Tesla, Inc. Service Bulletin		<h2>Replace Front Aft Links, China</h2>	
SB-20-31-008 October 23, 2020			
Classification Recall Bulletin		Section/Group 31 - Suspension	Mobile Service Cannot Perform
Model Year 2015 - 2017	Model Model S, Model X	Country/Region China	Version All
<small>The model(s) and model year(s) listed are a general approximation of the affected VIN list. Refer to the VIN/Bulletin Tracker or Customer/Vehicle profile to determine applicability of this bulletin for a particular vehicle.</small>

Figure 2 – Bolt head facing away from the HV battery (Model S LH shown, Model X and RH similar)

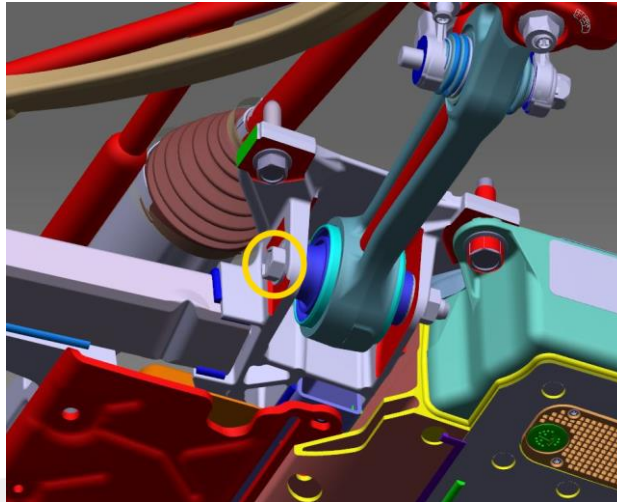
- If **both** bolt heads are facing away from the HV battery (Figure 2), continue to step 10.
- If only one aft link needs replacement, and the bolt head attached to that aft link is facing away from the HV battery, continue to step 10.
- If a bolt head is facing toward the HV battery, and the front aft link attached to that bolt needs replacement, continue to step 4.

**NOTE:** Make sure the new front aft link to subframe bolt(s) are installed with the bolt head facing away from the HV battery.
